Inspection Photos

Operator: ST CROIX OPERATING INC - 81490

Location ID: 455607

Inspection Doc. Number: 682504213

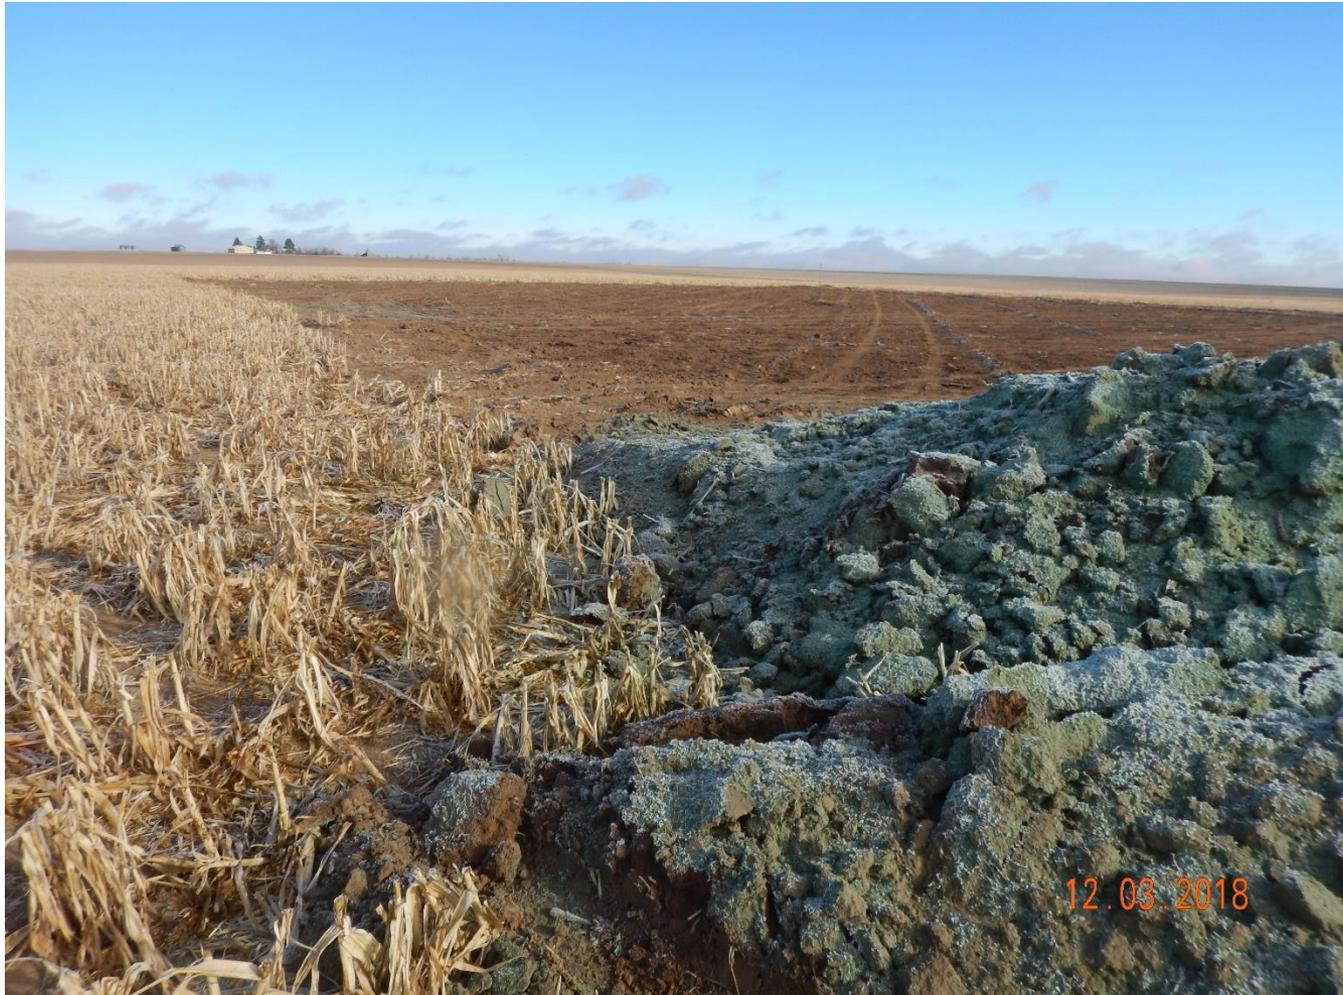
Photo 10: Photo taken from the northwest corner of the location. Photo shows operator appears to have conducted soil salvage operations, however, sufficient soil salvage does not appear to have been conducted on the entire location in accordance with 1002.b. Photo shows areas on the north end compared to the reference; it is unlikely that the entire topsoil horizon has been salvaged in these area.
